Battersea Power Station

Review of the listed building consent application for the demolition and rebuilding of the four chimneys

23 September 2005

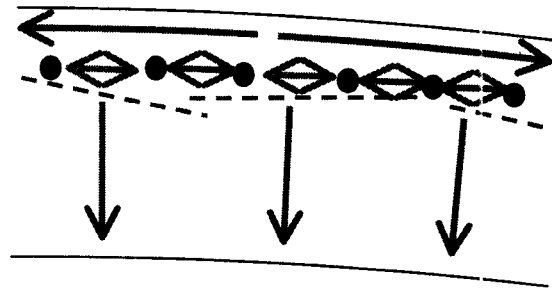
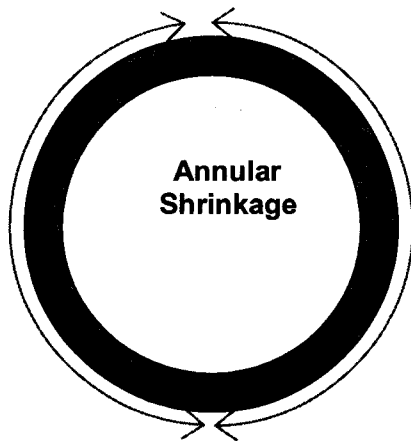
Throughout the review of the testing and assessment of the longevity and durability of the chimneys there has been difficulty in tracing connectivity between the various strands of data, all of which must by definition be derived from and relate to the four chimneys. The quality of reporting has increased this difficulty: for example only minimal information has been reported on the cores where compliance with BS1881:Part 120 would have been expected. Given that the entire purpose of the investigation was to assess the remedial needs of the chimneys as a conservable architectural feature then it is surprising that detailed photography has not accompanied every test and exposure carried out.

TITLE: **LIKELY CAUSES OF CRACKS**

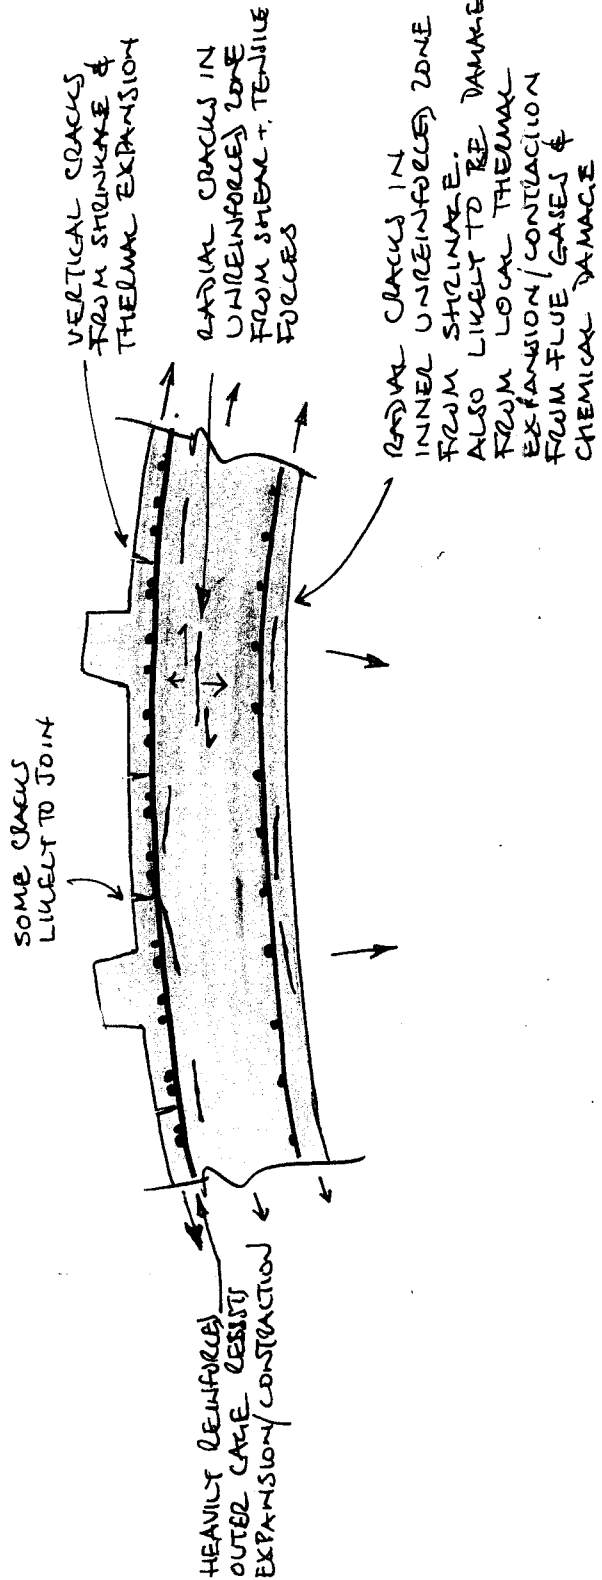
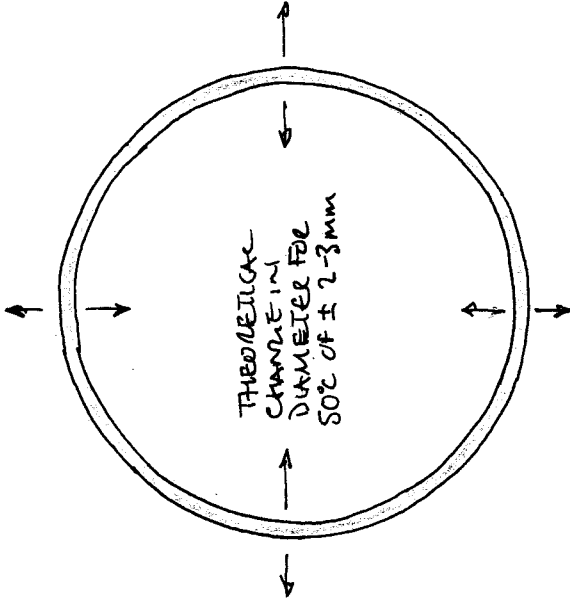
The annulus however means the shrinkage is unrelieved, causes the shrinkage to appear as compression on the helical steel, which is well designed to resist this. Linear, vertical shrinkage cracks in the concrete cover to the outer reinforcement will be the inevitable result. These cracks have been recorded on elevation drawings, albeit with the cracks shown at a much larger scale than is actually the case. The core concrete beyond the outer reinforcement is however unrestrained and the annulus diameter reduces, generating a stress field between the restrained outer and the unrestrained inner, with significant shear developing parallel to the external face.

DRYING SHRINKAGE

THERMAL EXPANSION + CONTRACTION
